## SERVICE LETTER

No. 51  
Nov. 15, 1996

TO: All users of Onboard Systems P/N 528-010-00.  
(Talon 3500 lb. Cargo Hook)

SUBJECT: Drain Holes

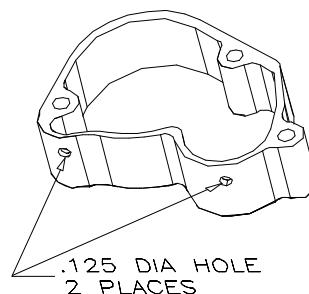
REASON: To Prevent Manual release mechanism from filling with water and freezing and interfering with manual release function.

It is possible for the area of the hook that encloses the manual release mechanism to become partially filled with water when washing the aircraft or from driving rain. The water enters around the hole for the manual release lever. The water can lay in the bottom of the chamber and later freeze. The ice could jam the manual release cable and mechanism. To prevent this from occurring we have added drain holes to the P/N 290-299-00 cover on production units from S/N 029 and on. For serial numbers 028 and lower we are recommending that two .125 dia. holes be drilled in the P/N 290-299-00 cover. Touch up the holes with Alodine after drilling.

We would be happy to do this modification for you or send you a new cover at no charge if you prefer. Please give me a call and we can arrange a plan that is most convenient for you.
